This document gives pertinent information concerning the reissuance of the VPDES Permit listed below. This permit is being processed as a Major<sup>(1)</sup>, Municipal permit. The discharge results from the operation of a 1.0 MGD wastewater treatment plant. This permit action consists of updating the proposed effluent limits to reflect the current Virginia WQS (effective January 6, 2011) and updating permit language as appropriate. The permit also contains proposed effluent limits for a design flow of 0.97 MGD wastewater treatment plant. The effluent limitations and special conditions contained in this permit will maintain the Water Quality Standards of 9VAC25-260 et seq.

1. Facility Name and Mailing Address: Dahlgren Wastewater Treatment Plant  
9207 Kings Highway  
King George, VA 22485  
SIC Code : 4952 WWTP  
Facility Location: 16383 Dahlgren Road  
King George, VA 22485  
County: King George  
Facility Contact Name: Jeff Hockaday  
Telephone Number: 540-775-2746  
Facility E-mail Address: [jhockaday@co.kinggeorge.state.va.us](mailto:jhockaday@co.kinggeorge.state.va.us)

2. Permit No.: VA0026514  
Expiration Date of previous permit: January 11, 2014  
Other VPDES Permits asso

1) Plant upgrade construction adjacent to headworks.

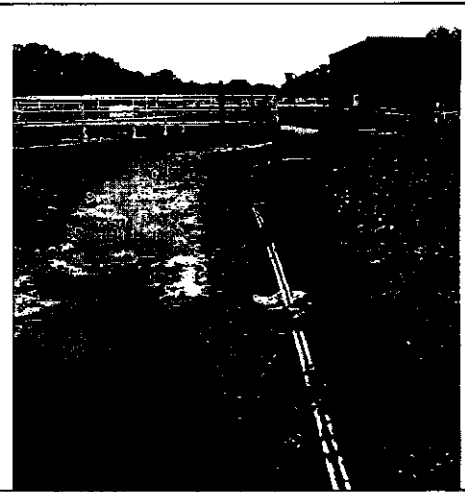
- **Plant upgrade construction was observed adjacent to the headworks. The pipes seen in Photo 2 send flow from the belt filter press and backwash of aqua filters to the headworks.**
- **A new step screen has been installed at the headworks prior to the grinder.**
- **An in-line grinder pump "muffin monster" is installed prior to the influent pumps.**
- **Debris observed downstream of this process unit, wet well and oxidation ditch. Mr. Hockday said operations staff have not had a chance to remove the floating debris in the wet well and oxidation ditch since the new step screen has been placed online.**
- **Photos 1-4**

5) EQ Basin

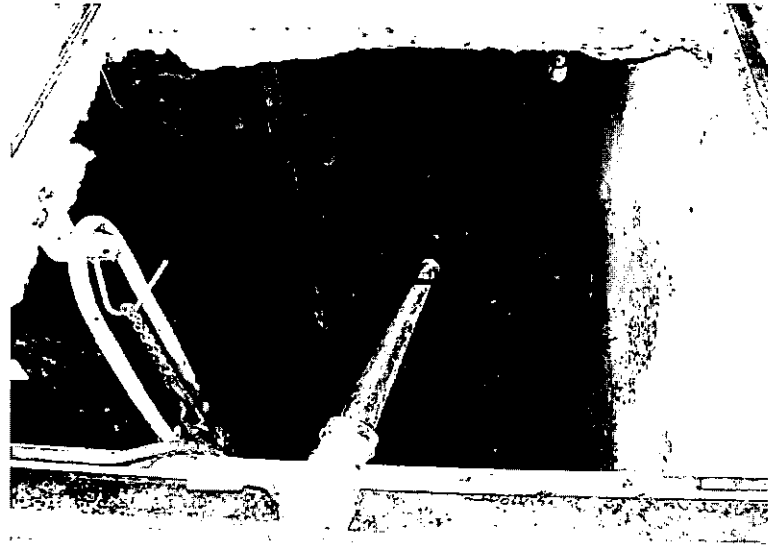
- 6. The EQ basin receives influent from plant drains and is used to hold influent during high flow periods. Influent can be diverted into the lagoon from the influent pump station and drained back when the water level reaches the predetermined level. Photo 5**
